**TO:** Mills City Council  
**FROM:** Megan Nelms, AICP, City Planner  
**DATE:** January 8, 2024  
**SUBJECT:** 257 Business Park – Preliminary Plat

**Case Number:** 23.08 FSP

**257 Business Park**

**Preliminary Plat**

# PRELIMINARY PLAT OF 257 BUSINESS PARK

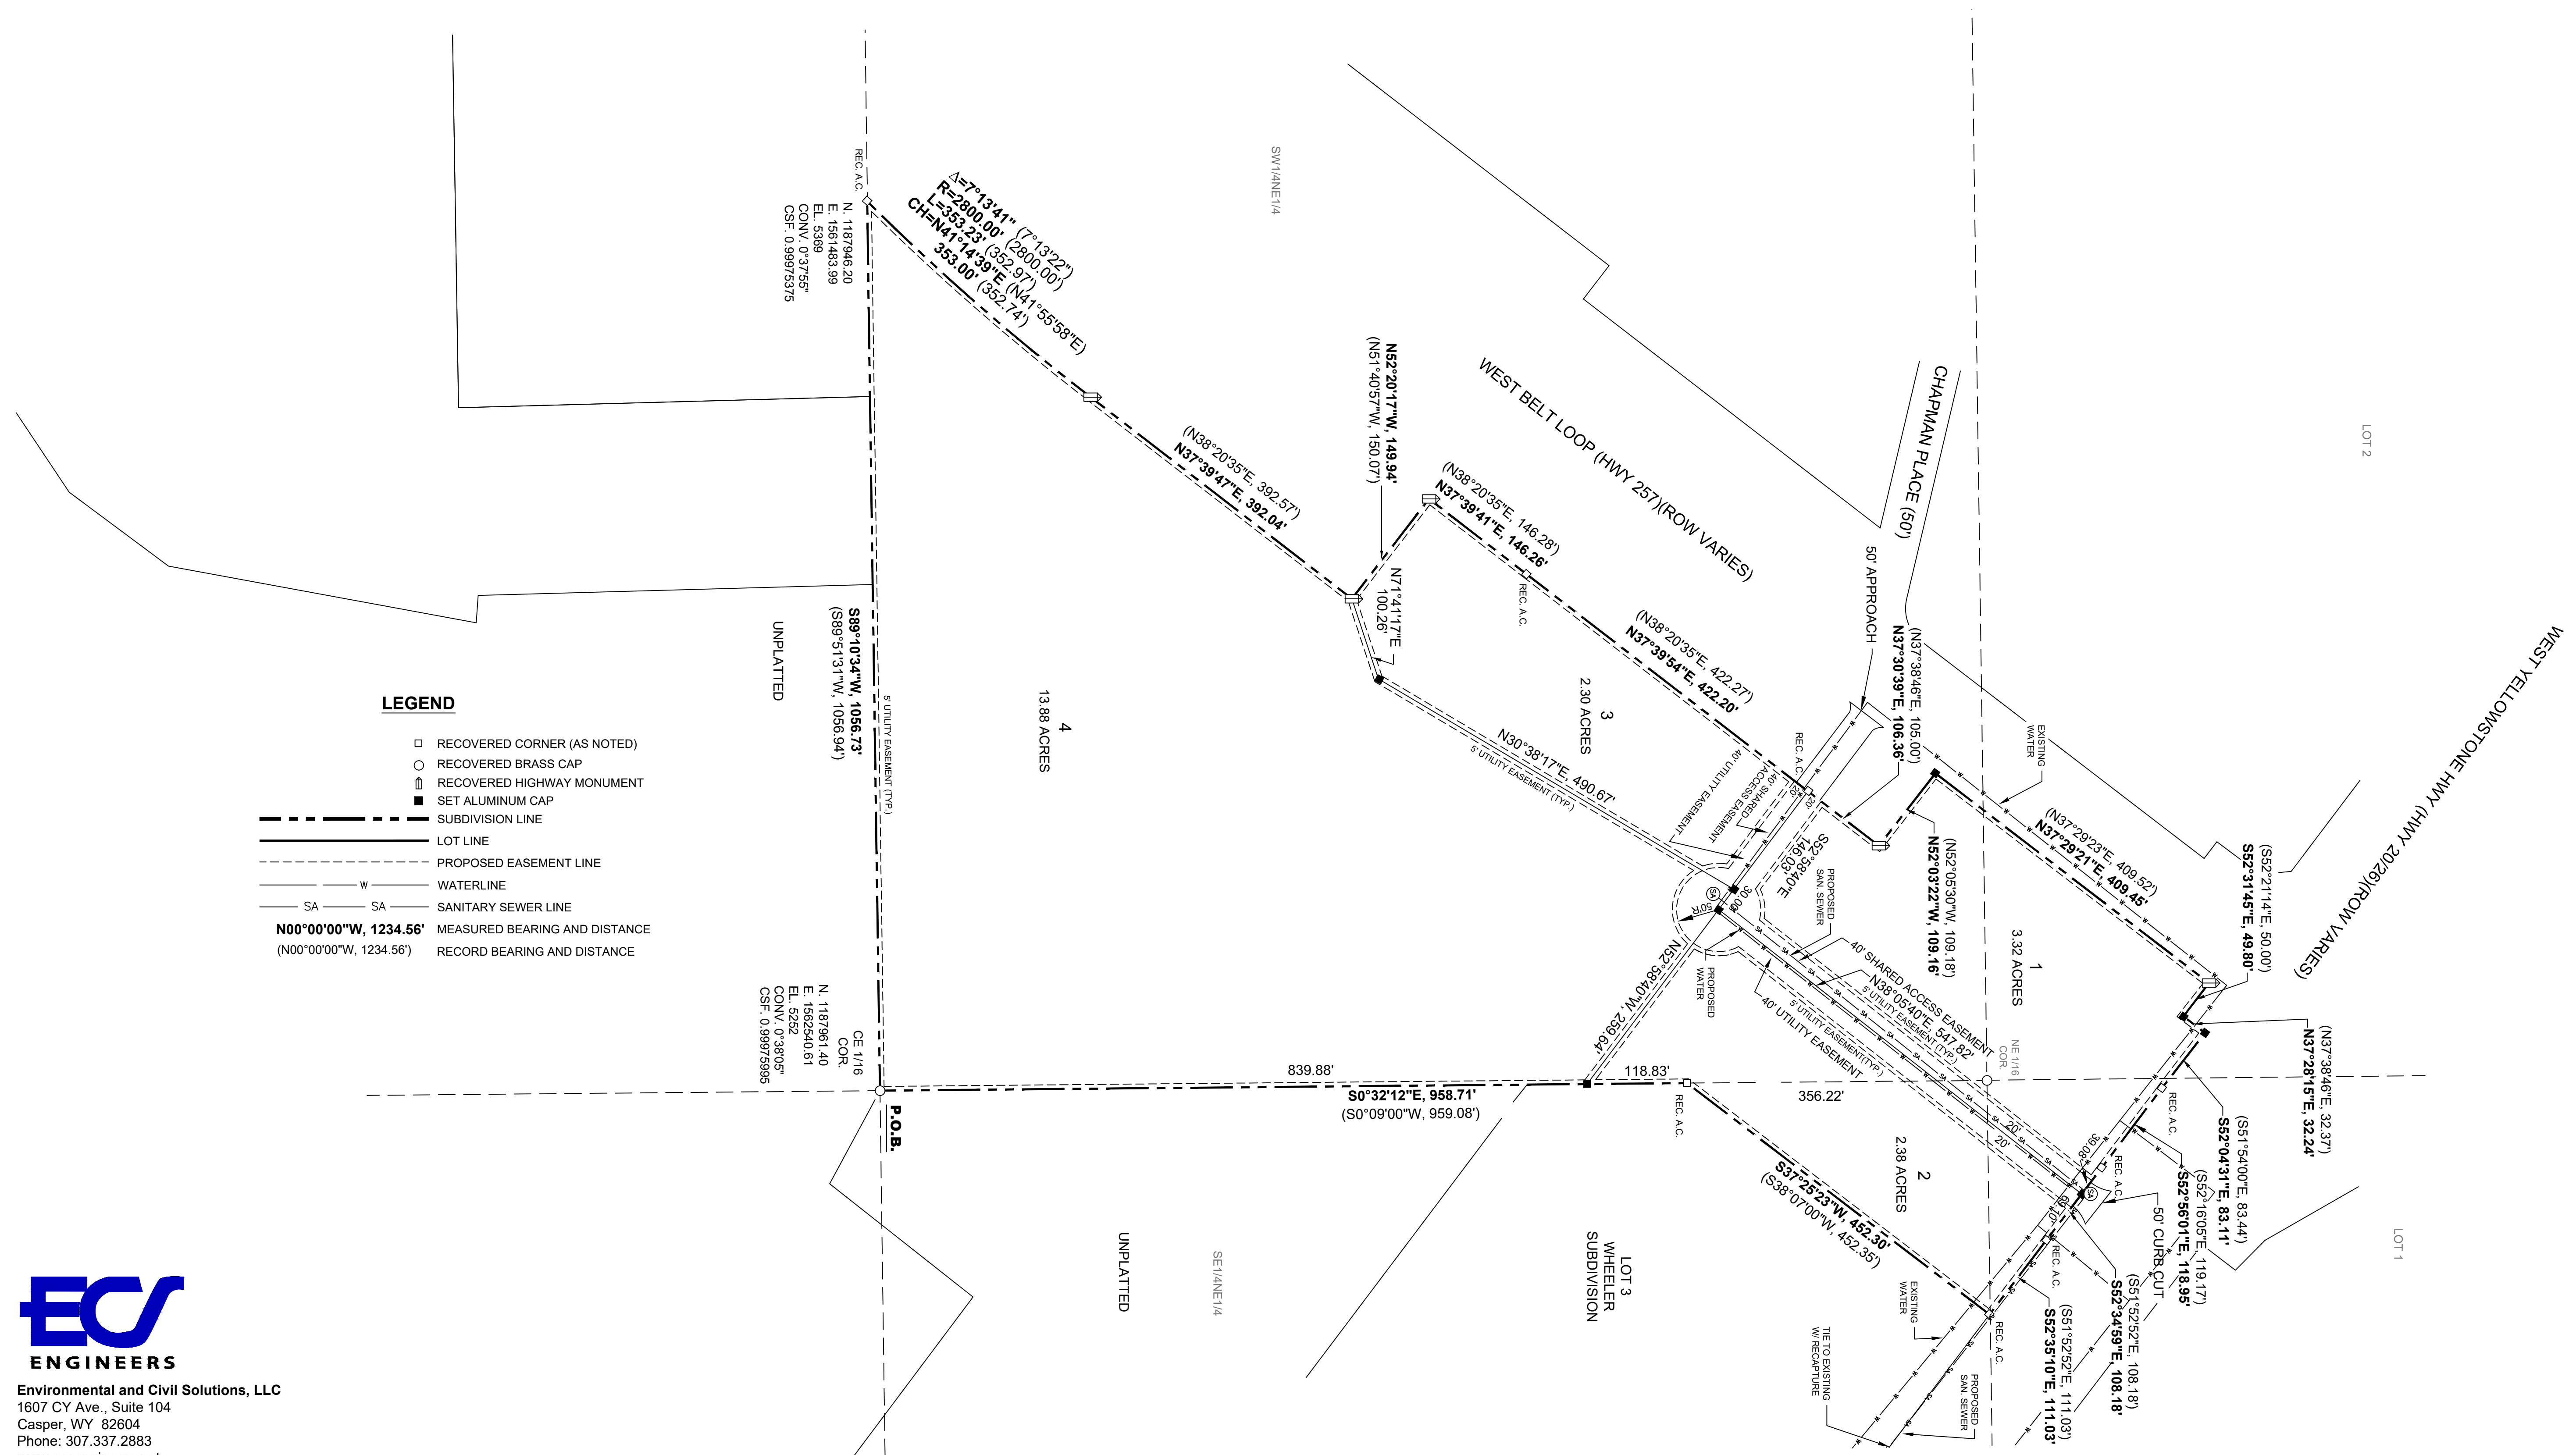
- Infrastructure Improvements (Chapter 16.16).
- b. Per 16.16.060, the minimum right-of-way/access easement width for a local street within low density development is 50’.

3. Add road names to all streets within the subdivision
    - a. The access between Lots 1 & 3 should be named Chapman
    - b. Provide a name for the access between Lots 1 & 2

6. All cul-de-sacs shall have a diameter of no less than 96’.
  7. Delineate the drainage easement on one of the lots, instead of showing it as its own parcel.

8. Survey Review:
    - a. Add State Plane Coordinates, northing, easting, elevation, Convergence and Combined Factor to two (2) of the exterior corners.

- b. The coordinates are in grid but the distances are in ground
    - c. Verify the north corner(s) of the plat and Lot 1. Review Instrument #866007 as excepted in Instrument #1143765, with regard to the WYDOT parcel.

- d. There is a mis-closure of Lot 4 by 1.63 feet
  9. Cosmetic Revisions to the Plat:
    - a. Add TO THE CITY OF MILLS under “Plat of 257 Business Park” in the title block on both plat sheets.

- b. Make the adjacent subdivision and road names gray.

Staff recommends DENIAL of the preliminary plat. Adopted Design Standards require a minimum width of 50’ for all public right-of-way/access easements.
